Technical Service Bulletin: tsb100935

Released Date: 03-May-2010

Obsolete Lift Pump Gaskets

Figure 1, Fuel Transfer Pump Assembly - (1) Gasket, (2) Fuel Transfer Pump, (3) Mounting Support, 4) Capscrew

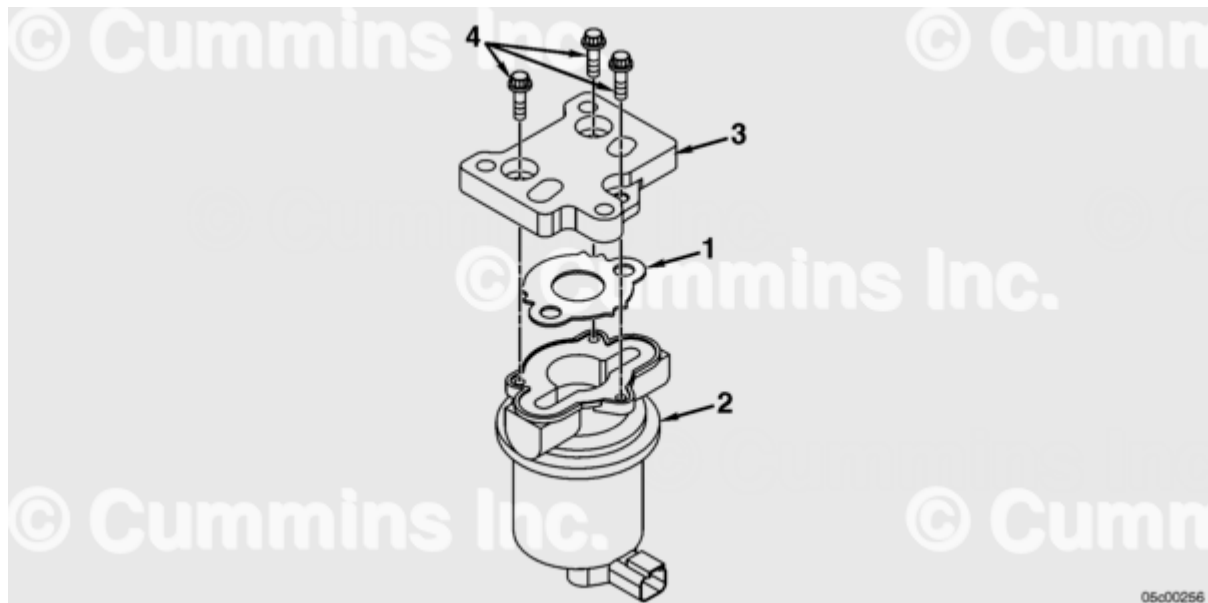
The ISX transfer pump assemblies consist of a fuel transfer pump and a mounting support. See Figure 1.

Lift pump gaskets, Part Numbers 4928511 and 4928512, introduced in SPT 05T5-27 have been discontinued and will no longer be available after present inventory is depleted; therefore, it will be necessary to replace the entire lift pump assembly. Present production and service lift/priming pumps contain a number of revisions to improve quality and durability. The supply and discharge port locations have been changed. The gasket material has been updated to a more robust

material and self-tapping capscrews are used to mount the pump to the support. These changes were made to reduce fuel leakage. Present lift/priming pump part numbers and a cross reference can be found below and in SPT 08T5-13, ISX Transfer Pump Obsolete without Supersession.

The mounting support design can vary from the one shown in Figure 1.

The release date for the revised lift/priming pump for service is 17 January 2008.

The engine serial number (ESN) first is 79290014.
